Skidoo ZX DPM Update Instructions

We're sending you a plastic check valve to replace the brass-colored orificed cup plug originally shipped in your kit.

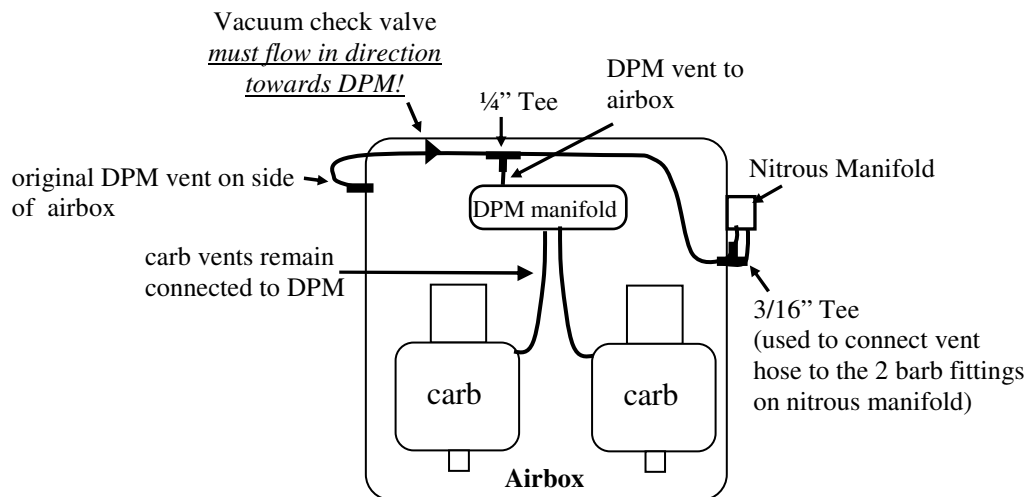
This check valve will allow the nitrous manifold to build more pressure inside the DPM. Remove the orificed cup plug and insert this check valve as shown below.

1. Connect the Plastic Vacuum **Check Valve** so it is in-line between the original DPM vent on the airbox and the 1/4" Tee. Be sure the check valve allows air to flow towards the DPM from the airbox (White end towards airbox vent, Black end points towards DPM). Double check that the check valve flows the right direction by blowing on it both directions. **If the check valve is backwards, you will be too lean on nitrous!**
